ARCHITECT'S SUPPLEMENTAL INSTRUCTIONS

PROJECT: Joan M. Durante Community Park
(name, address) Longboat Key, FL

ARCHITECT'S SUPPLEMENTAL
INSTRUCTION NO.: 3

DATE OF ISSUANCE: 01/09/95

SK-3

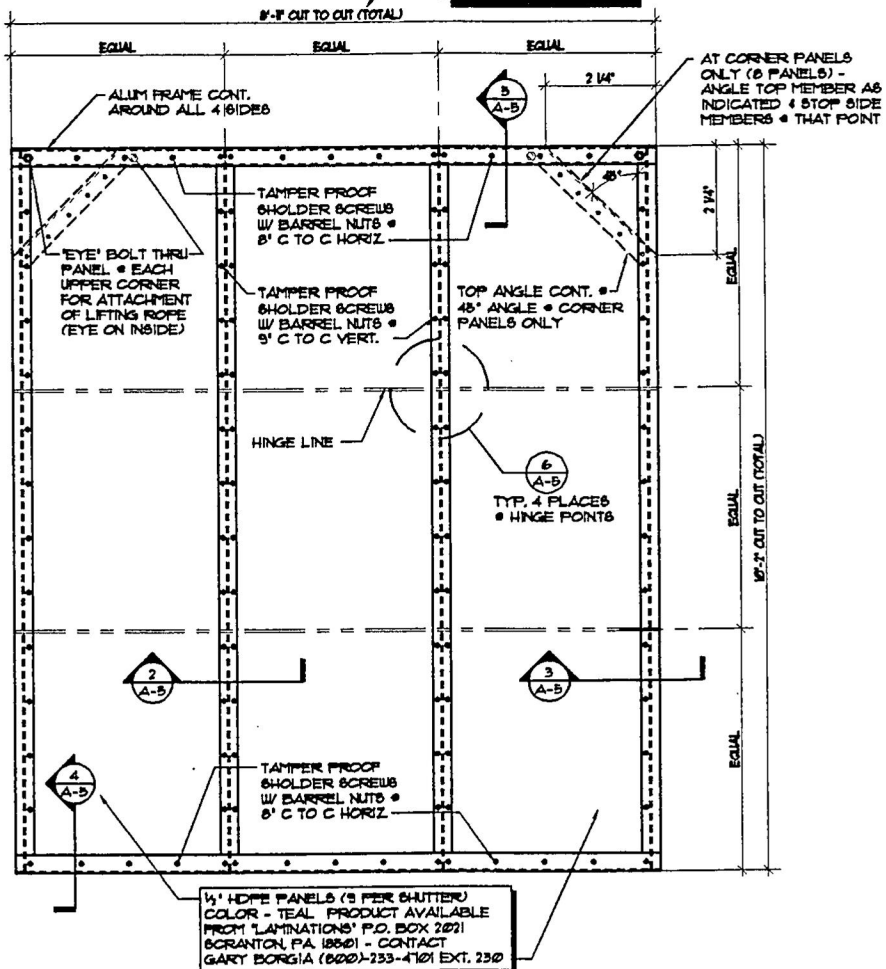
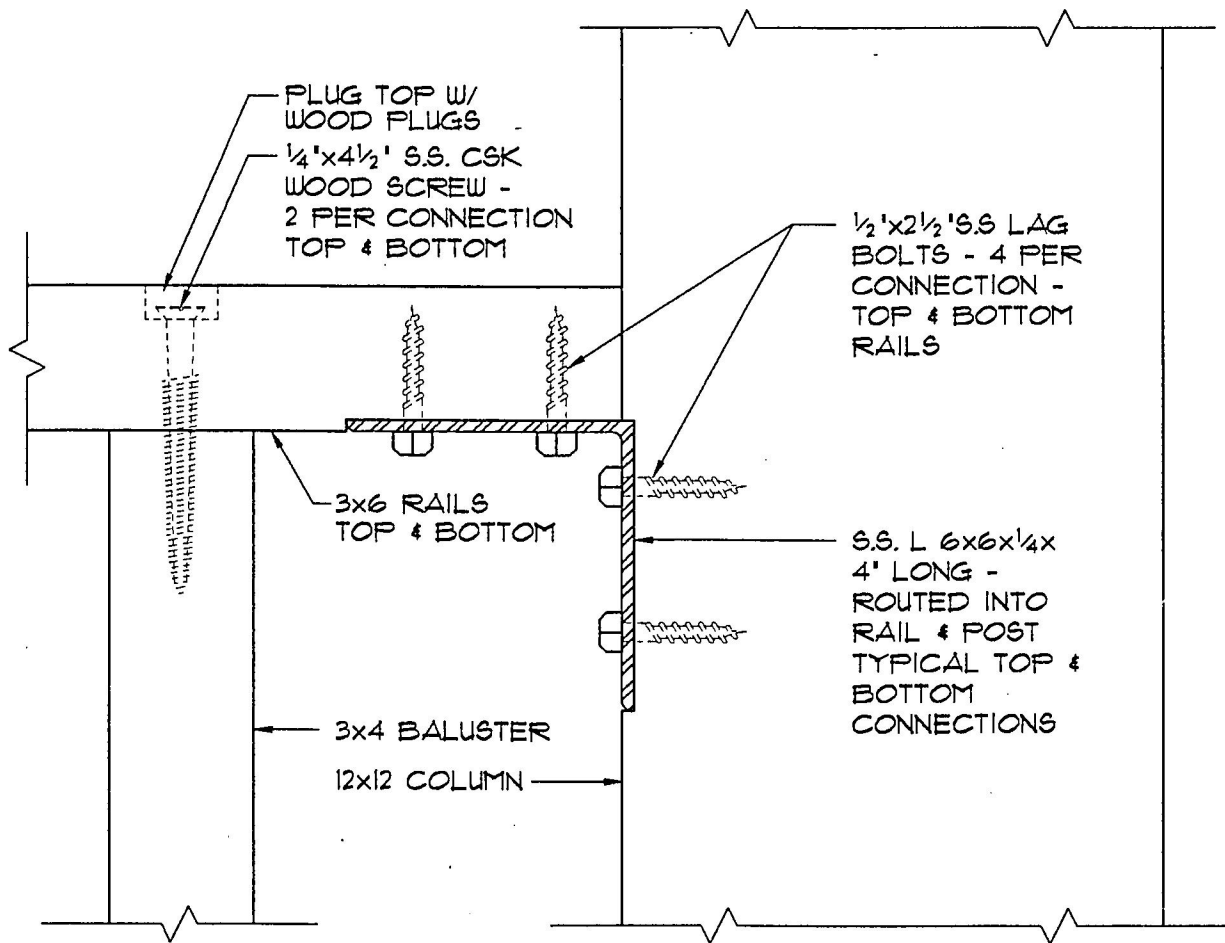
9. Operable security shutter at entry stairs and handicapped ramp to be narrower to avoid handrails per attached sketch SK-3.

NOTE:
AT ENTRY STAIRS
AND H/C RAMP PANEL
WIDTH SHALL BE 8'-0" DUE TO HAND RAILS.

SK-5

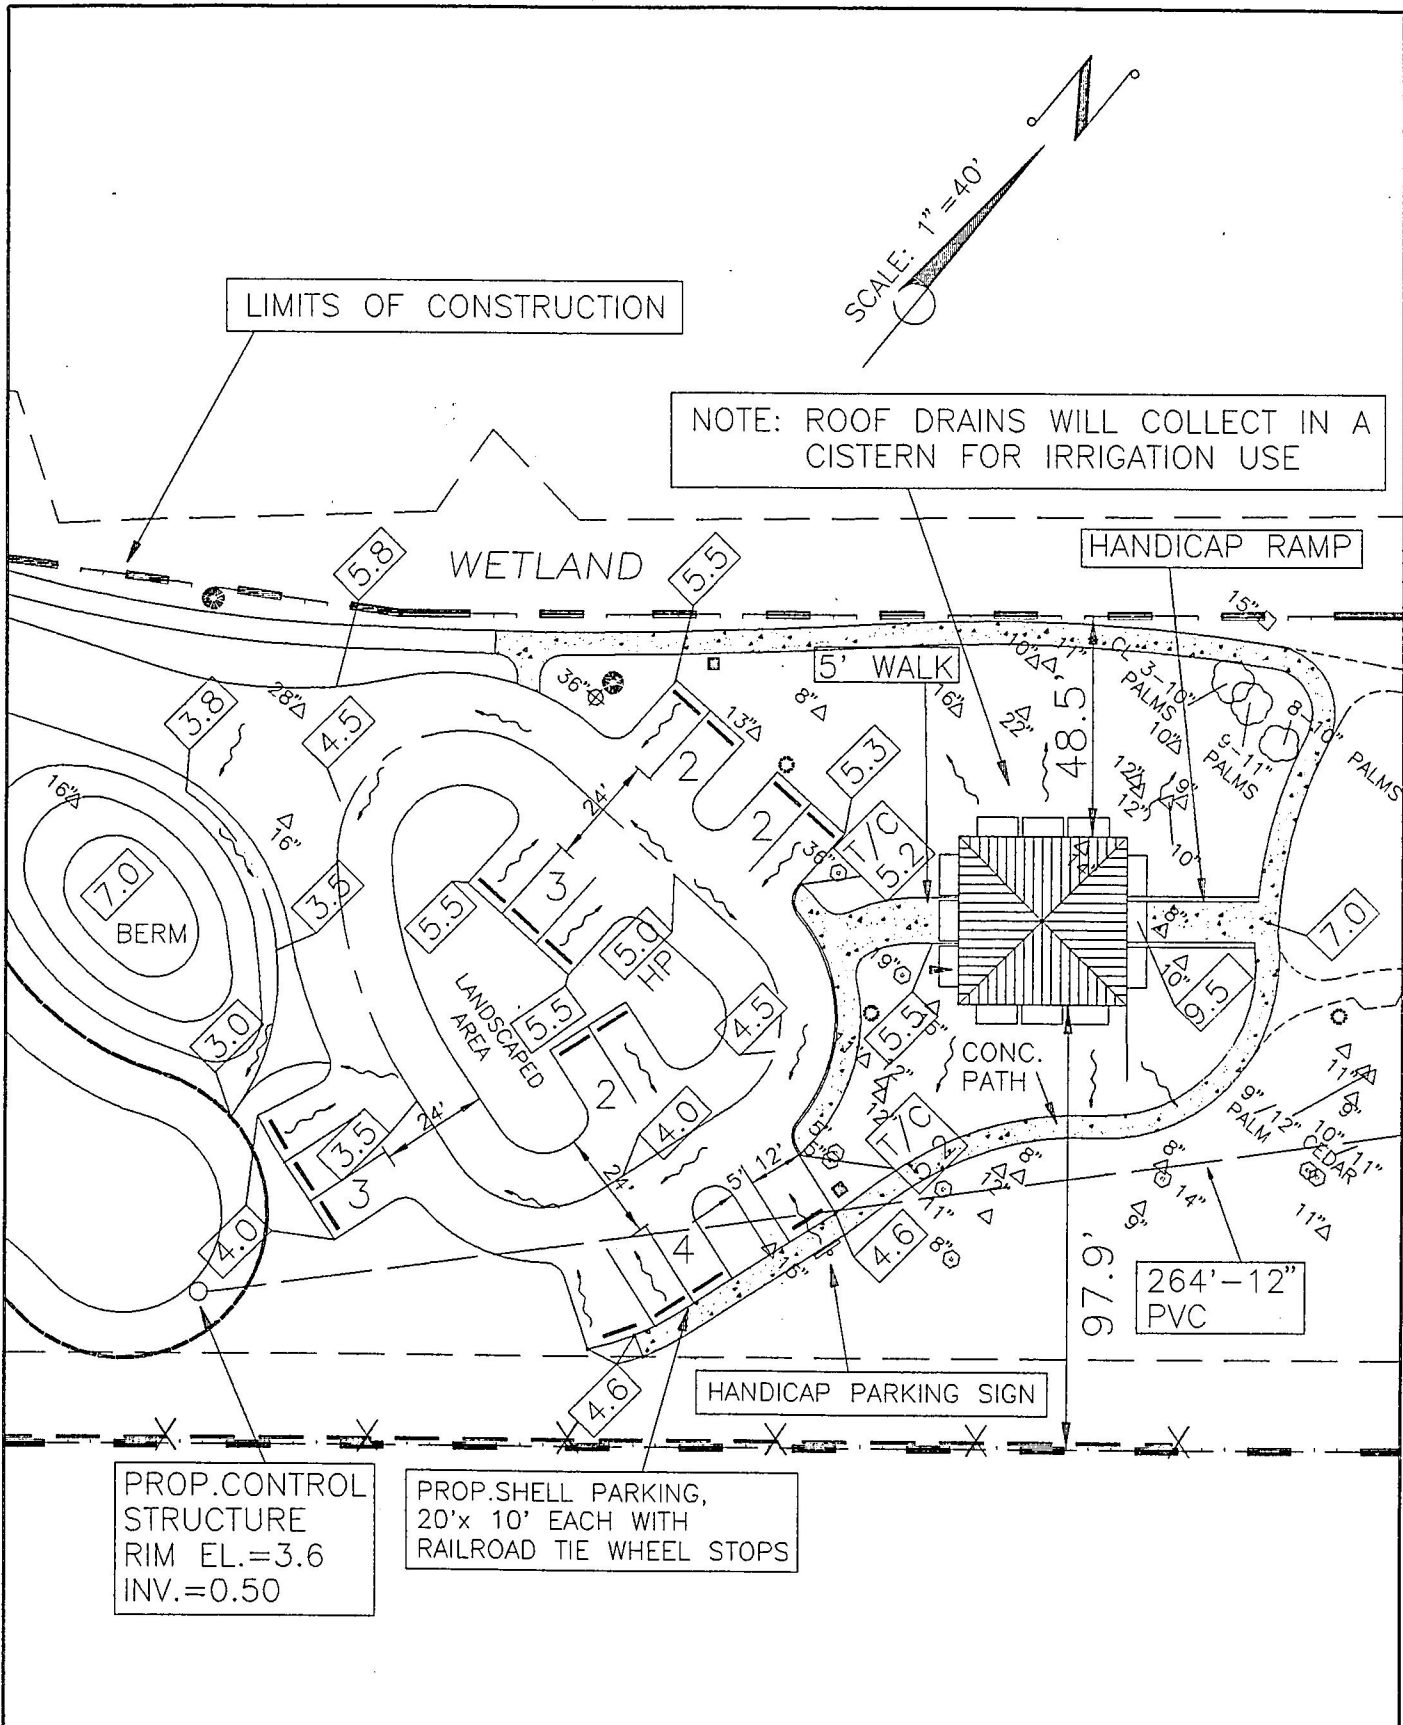
5. Move 1 parking space from northeast parking area to southwest area per attached sketch SK-5.
6. Move 2 parking spaces from southeast parking area to southwest area per attached sketch SK-5.

7. Dimensions of parking aisle and handicapped parking space are indicated on attached sketch SK-5.
8. Anchorage of guardrails to columns in Welcome Center Pavilion is indicated on attached sketch SK-4.
